Our ref: DOC22/324389
Your ref: SSD-10807896

Thunderbolt Wind Farm (SSD-10807896) – environmental impact statement

BCS has reviewed the biodiversity development assessment report accompanying the EIS.

Figure 1 Example of mapping of derived native grassland (DNG)

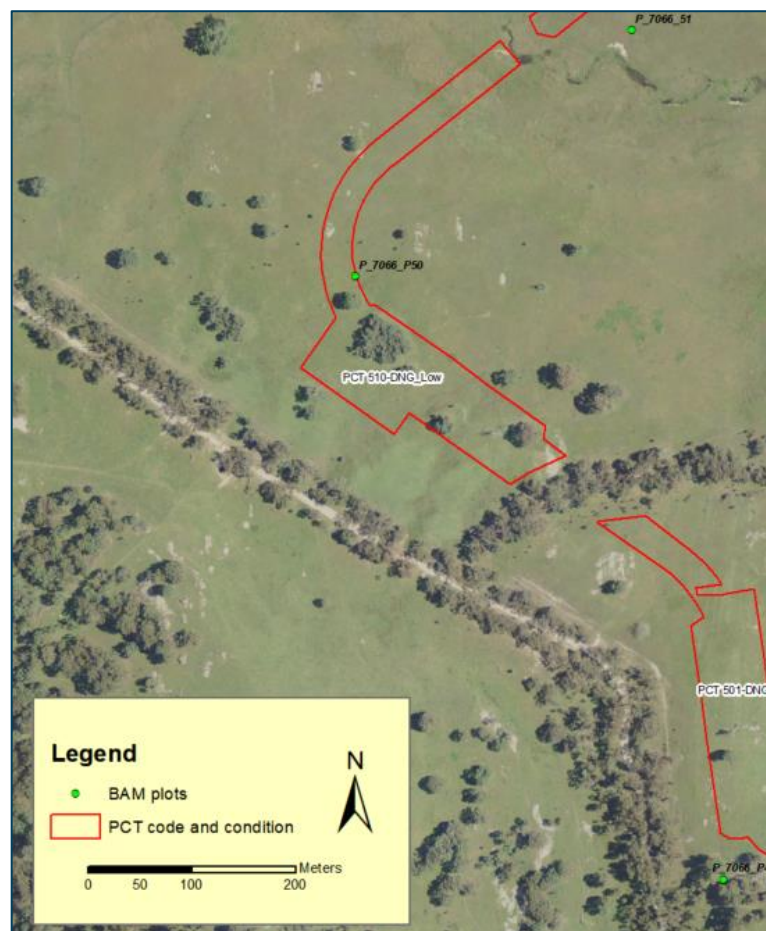
There are areas mapped as derived native grassland (DNG) that contain trees that would be better described and assessed as woodland. For example, figure 1 shows an area mapped as PCT 510 DNG_Low which clearly has trees.

To guide woodland mapping, *BCD North East Branch – Principles for mapping the extent of woodland critically endangered and endangered ecological communities* is provided in **Attachment C**. These principles should be applied to all areas currently mapped as DNG. Areas assessed as woodland following application of the principles should be allocated to woodland zones and biodiversity credits recalculated accordingly. Additional BAM plots may be required.

- 8.1 PCT mapping of DNG be reviewed following the *BCD North East Branch – Principles for mapping the extent of woodland critically endangered and endangered ecological communities*.
- 8.2 Areas assessed as woodland should be allocated to woodland zones and biodiversity credits recalculated.

Figure 2: Location of BAM plots for PCT 559

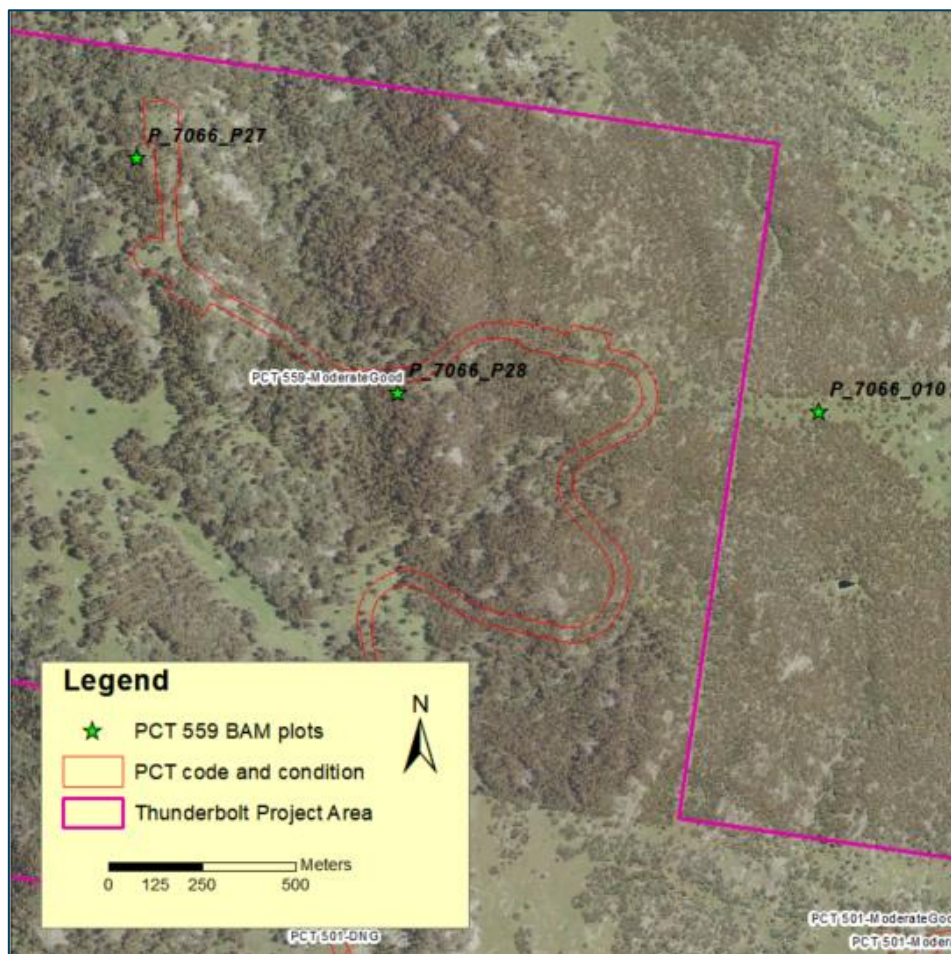
- Plot P_7066_010 in PCT 559 Moderate / Good: BAM data for this plot does not match the other two plots in this zone. An additional vegetation condition zone for PCT 559 may be required. In addition, this BAM plot has been included in the BAM calculator and the plot data spreadsheet but has not been included in the spatial file BAM_Plots_mga56.shp provided to BCS. BCS note that this plot has been located in a more open area about 400 meters east of the project footprint outside of the project area (figure 2).

- 9.1 Data in the BAM calculator be checked to ensure accuracy with plot data and spatial data.
- 9.2 Allocation of vegetation zones for PCT 559 be reviewed.
- 9.3 All BAM plots used for credit calculations be included in the spatial file.
- 9.4 The BDAR and BAM calculator be updated to incorporate changes.
